January 11, 2017

SUBJECT: NATIONAL INSTITUTE OF STANDARDS AND TECHNOLOGY– STAFF
ASSESSMENT OF APPLICABILITY OF FUKUSHIMA LESSONS LEARNED TO
THE NATIONAL INSTITUTE OF STANDARDS AND TECHNOLOGY CENTER
FOR NEUTRON RESEARCH TEST REACTOR

STAFF ASSESSMENT OF APPLICABILITY OF
FUKUSHIMA LESSONS LEARNED TO THE NATIONAL INSTITUTE OF STANDARDS
AND TECHNOLOGY CENTER FOR NEUTRON RESEARCH TEST REACTOR
LICENSE NO. TR-5; DOCKET NO. 50-184

Figure 3.2-1. Estimated Shear Wave Velocity Profile with Depth at the NBSR Site. Measured Velocity at Reston, Virginia, Fire Station is Also Shown for Comparison.

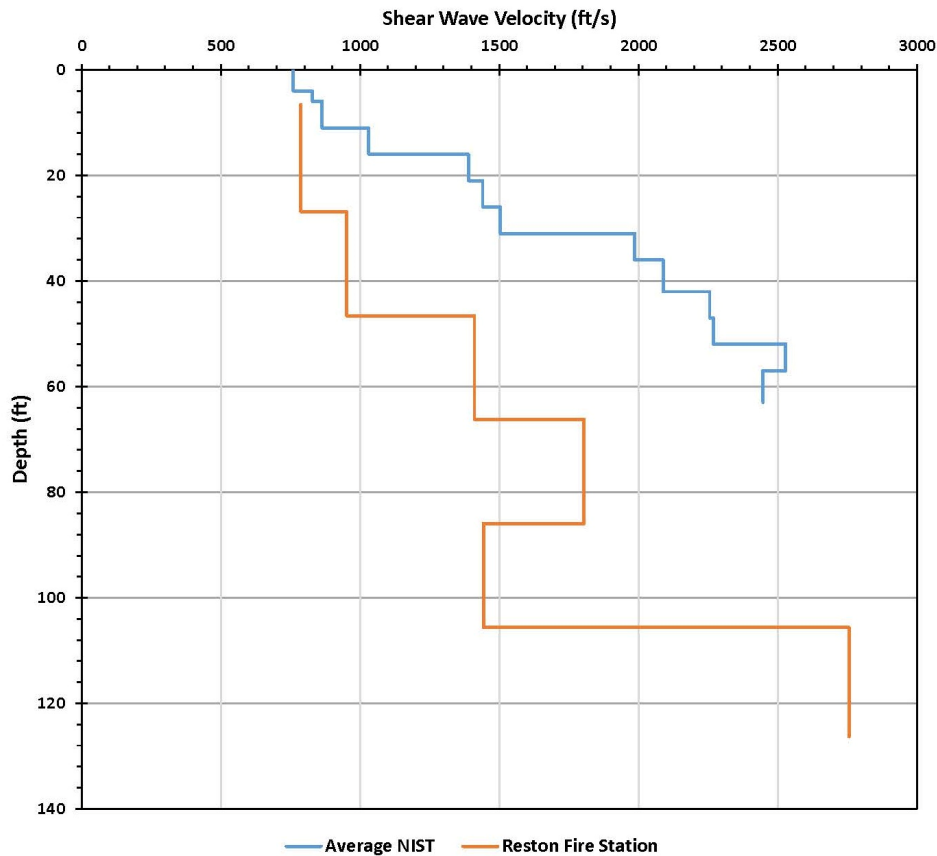
No information is available on the shear wave velocity of the underlying subsurface materials at the NBSR reactor site (NIST, 2004; URS, 2003). The NRC staff has conducted an extensive literature search for information of the shear wave velocity measured in nearby areas. Available information is sparse and from locations far away from the NBSR facility. Additionally, the information is also from shallow depths not reaching far enough to encounter the general rock conditions, defined as rock layers having a shear wave velocity of 2.8 km/s [9,200 ft/s] (NRC, 2007a). As an alternative, the NRC staff has used empirical relationships available in the literature for converting the SPT blow counts to estimated shear wave velocities. For example, the relationship proposed by Seed, et al. (1983) have been used to estimate the shear wave velocities of sand, silty sand, and sandy silt layers from reported blow counts. Similarly, Rollins, et al. (1998) have been used to estimate the shear wave velocity of decomposed shaley schist assuming it is represented by gravel. Ohta and Goto (1978) have been used for fine sand layer with quartz and rock fragments assuming coarse sand would represent the material. Lee (1992) has been used to estimate the shear wave velocity of clayey silt. The estimated shear wave profile, calculated as average of the boreholes, is shown in Figure 3.2-1. This figure also shows the shear wave velocity measured at the Reston, Virginia, Fire Station (Kayen, et al., 2015), approximately 24 km [15 mi] south of the NBSR site. Figure 3.2-1 shows that the estimated shear wave velocities at the NBSR facility are substantially higher than that measured at Reston Fire Station, although the general trend is similar. Lack of any other information from the NBSR site has precluded resolving the uncertainties associated with the estimated shear wave velocities at the NBSR facility.

As observed in the boreholes at the NBSR site, the strata below the saprolite-rock boundary are fragmented. The fragmentation decreases with depth. Therefore, the NRC staff has incorporated a transition zone with gradually increasing shear wave velocity at the NBSR facility because the fragmentation of the rock decreases with depth. However, the rate of shear wave increase and the depth at which the general rock condition would be encountered are unknown. The NRC staff has conducted a sensitivity study with two values of the parameters to assess how the estimated PGA is affected by varying the weathered zone thickness: (i) the general rock condition occurs at a depth of 60 m [200 ft] from the surface and (ii) the general rock condition occurs at 75 m [250 ft] from the surface.

The NRC staff has developed two sets of material properties for estimating the site response. In Set 1, the entire strata below the NBSR reactor is considered as composed of weathered rock, followed by the bedrock with general rock conditions. The weathered rock represents the transition zone with increasing shear wave velocity with depth and is modeled having the weathered rock properties, as estimated at the North Anna nuclear power plant site (Virginia Electric and Power Company, 2015). The bedrock with general rock conditions are represented as a linear material with no damping. In Set 2, the material below the reactor is assumed saprolite for up to 3.3 m [11 ft] followed by the weathered rock transitioning to the bedrock with general rock conditions. Material properties of saprolite, as measured at the North Anna nuclear power plant site, are used to model the saprolite at the NIST site. Other subsurface

Figure 3.2-2. Mean Hazard Curves at the Control Point

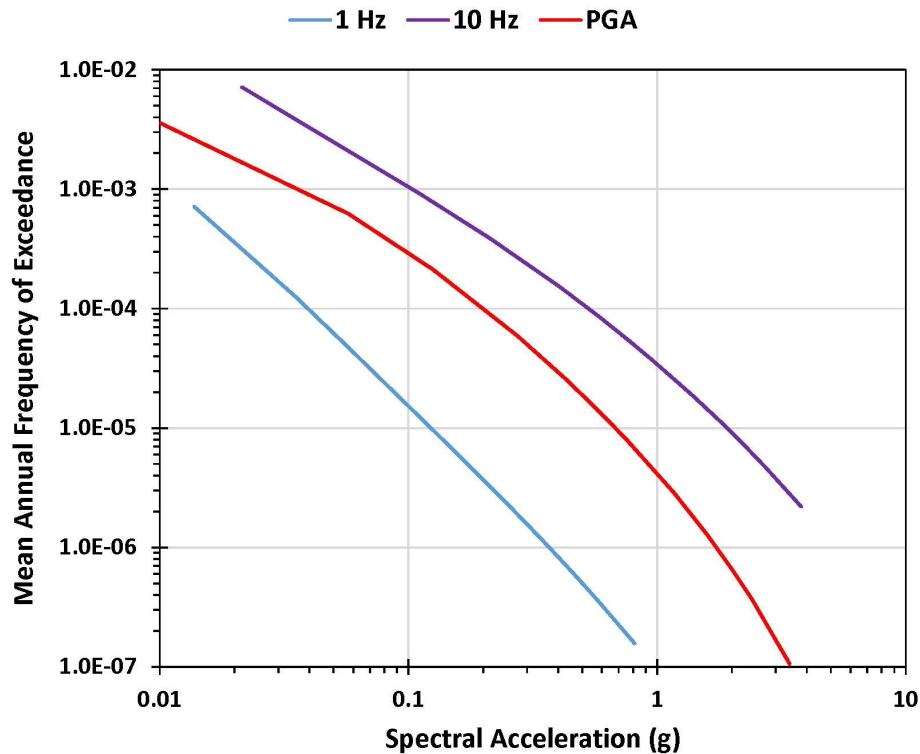
The NRC staff has estimated the seismic hazard curves at the control point using different combinations of the material properties, as discussed before. The estimated mean hazard curves using material properties with weights of 20 percent for Set 1 and 80 percent for Set 2 are shown in Figure 3.2-2. Other combinations of the material properties produce results similar to these.

As discussed before, a PGA of 0.1g was used to design the NBSR facility (NIST, 2004). Based on the USGS seismic hazard map, the NIST has estimated the design earthquake would have a probability of exceedance of approximately 2 percent in 50 year or a return period of 2,475 year (NIST, 2004; URS, 2003). The NRC staff has assessed whether the reevaluated seismic hazard at the NBSR facility site creates a significantly higher seismic demand.

The NRC staff has calculated the PGA from the PSHA and site response analysis. The PGA is estimated to be approximately 0.07g from Figure 3.2-2 with a return period of 2,500 year (i.e., approximately 2 percent probability of exceedance in 50 year). The estimated PGA is 0.03g lower than the PGA reported in the SAR and used to design the NBSR facility (NIST, 2004). In addition, several design features of the reactor at the NBSR facility add additional safeguards against radiological consequences, as discussed in NRC (2015). Therefore, the NRC staff concludes that no additional assessment would be needed based upon this evaluation.

Figure 1 Drainage sub-basins, DA1, DA2, DA3, and DA4, are divided by red lines. Contours are shown in black lines. Upstream is on the right of the Building 235.

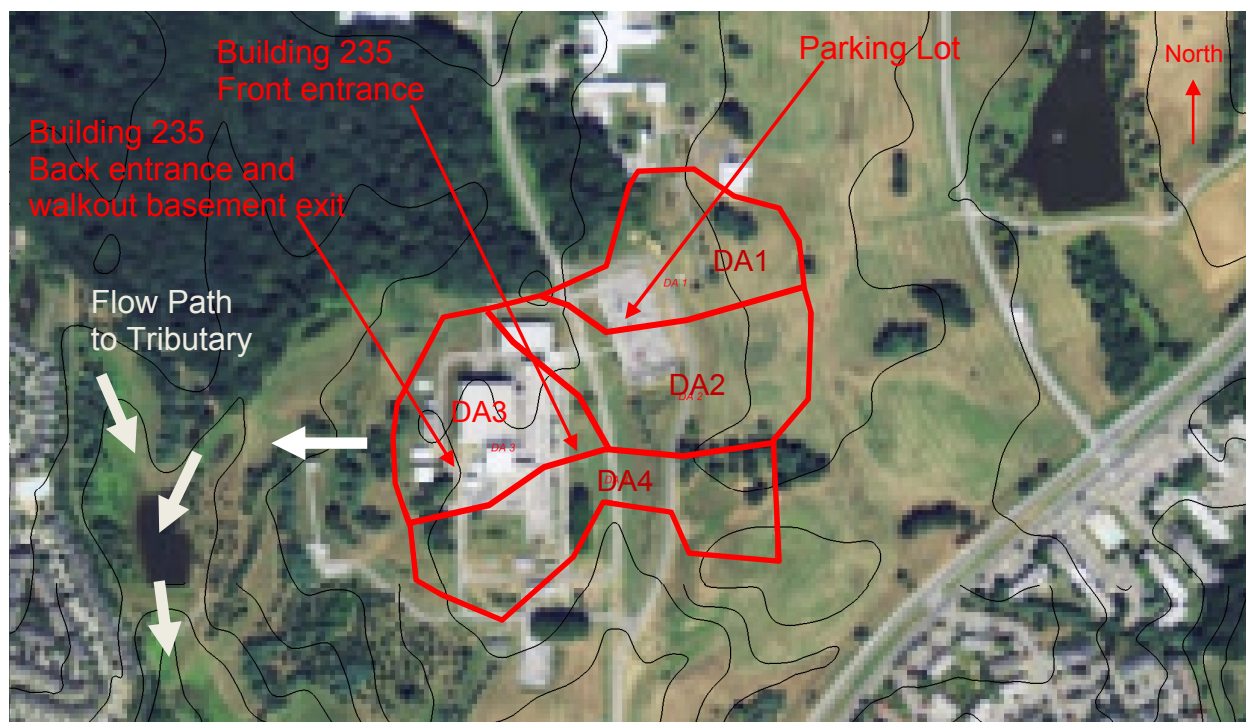
The NIST catchment area was divided into four sub-basins: DA1, DA2, DA3, and DA4 (see Figure 1). Sub-basins DA1 and DA2 contain the parking lot in front of Building 235 (reactor building). DA3 contains most of Building 235. The surface area of each sub-basin is shown on Table 1. The total catchment area is 32.54 acres [13.2 hectare] in Table 1, but in the flood hazard computations the total area is increased to 35 acres [14.2 hectare]. This increase was conservatively adopted to account for possible deviations due to estimating surface area.

NRC staff calculated the maximum depth of water in the front entrance of Building 235 to be approximately 1 ft [30.5 cm]. Adjacent to the walk-out basement entrance door to Building 235, surface water runoff will pond. NRC staff's bounding calculations estimated the depth of ponding to be approximately 10 in [25.4 cm]. Ponded water would persist against the door for approximately 2 hours following cessation of the rainfall event.
